Nomad ALERT SERVICE BULLETIN

WINGS — FLAP OPERATING LIMITATIONS

ANMD-57-18

Figure 1 Engine Power lever Aural Warning Microswitches

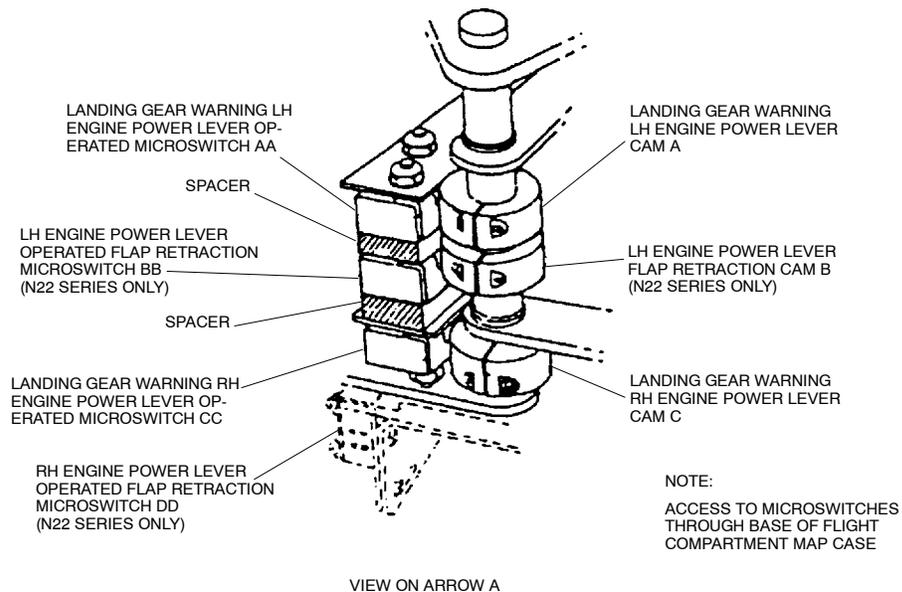
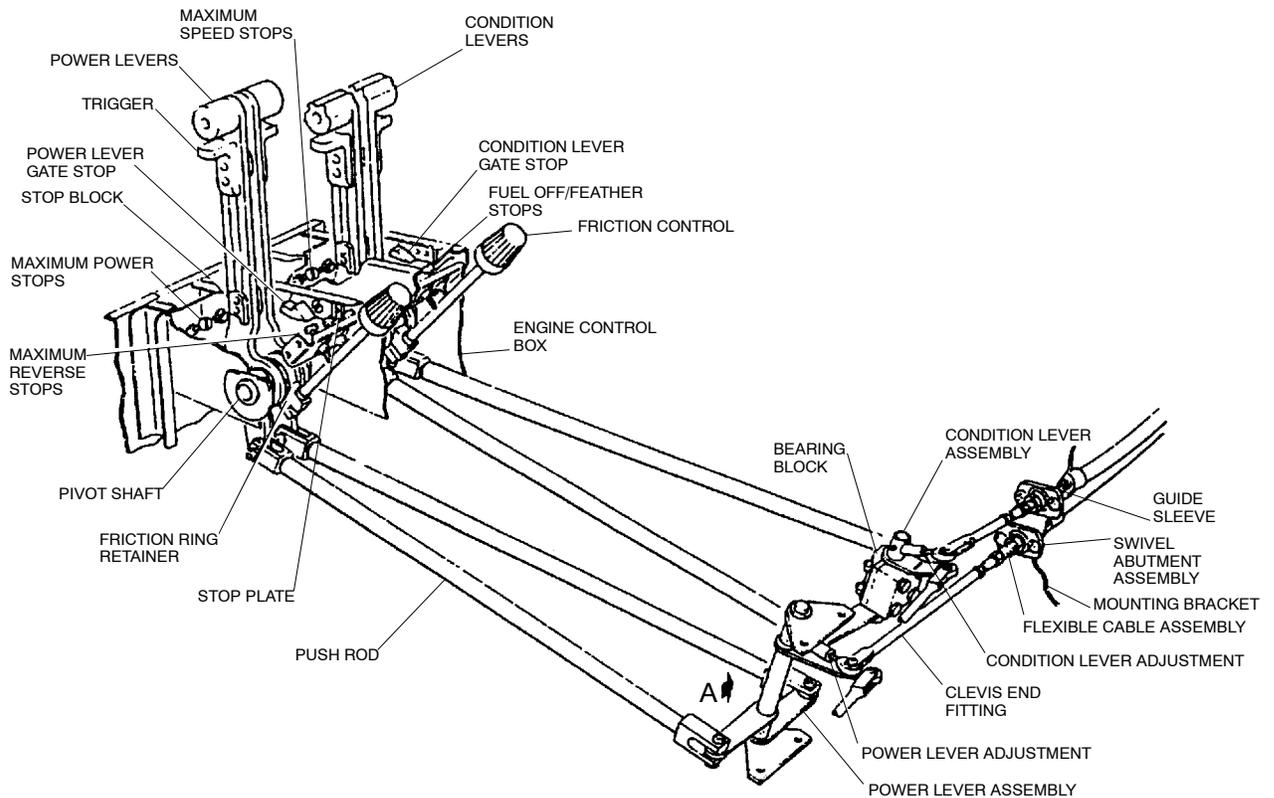
B. **Part 2 - Adjustment of Engine Power Lever Actuated Landing Gear 'UP' Aural Warning Microswitches (Ref Fig 1)**

- (3) Check that over-travel of AA and CC microswitches is between 0.020 in to 0.030 in. If necessary, adjust as follows:
 - (a) Loosen nuts on the microswitch mounting rods.
 - (b) Adjust microswitch position accordingly.
 - (c) Lock mounting rod nuts when over-travel adjustment is complete.
- (4) Confirm that all microswitches, when operated, have between 0.020 in and 0.030 in over-travel remaining.
- (5) Set both power levers to full forward.
- (6) Connect continuity tester across terminals C and NO of top microswitch AA.

- (7) Retard LH power lever to marked position corresponding to a torque pressure of 28.0 to 31.0 psi.
- (8) Adjust cam A by loosening two locking screws on the cam. If the continuity tester indicates continuity, rotate cam A until continuity is broken. Adjust cam A until continuity is just indicated and lock the cam adjusting screws.
- (9) Reset the LH power lever to full forward.
- (10) Retard the RH power lever to the marked position.

- (11) Adjust cam C by loosening two locking screws on the cam. If the continuity tester indicates continuity, rotate cam C until continuity is broken. Adjust cam C until continuity is just indicated and lock the cam adjusting screws.
- (12) Reset the RH power lever to full forward.
- (13) Disconnect the continuity tester.
- (14) Re-confirm the over-travel setting of each of the microswitches.

Check that over-travel adjustment of flap retraction microswitch BB, operated by LH engine power lever, remains within the limits 0.020 in to 0.030 in when operated. Also check that microswitch switch BB is activated at a torque pressure of 60 ± 5 psi (engine protractor angle $76^\circ \pm 2^\circ$). Lever operated flap microswitch DD for RH engine power is not affected by the adjustments.

Figure 5 N22S Flap Extension Limitation Placard

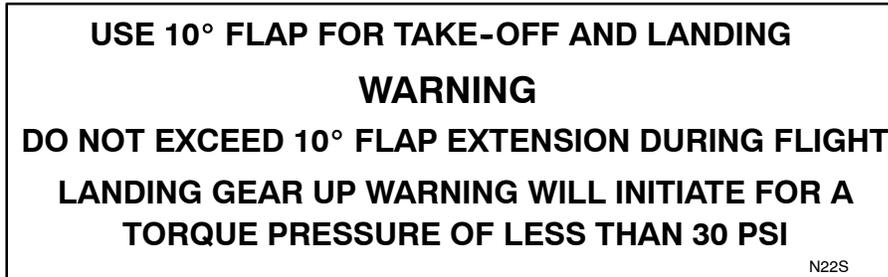
- (1) Replace N22B and N22C placards introduced by Service Bulletin ANMD-57-11, Revision 5, with new placard (Ref Fig 2 N22B and N22C).
- (2) Manufacture new placards as follows and locate on instrument panel where clearly visible to pilot:
 - (a) Figure 3 N24A Flap Extension limitation Placard.
 - (b) Figure 4 N22B and N22C Flap Extension Limitation Placard.
 - (c) Figure 5 N22S Flap Extension Limitation Placard.

- (1) N24A and N22S model aircraft: 10 degrees.
- (2) N22B and N22C model aircraft: 20 degrees.
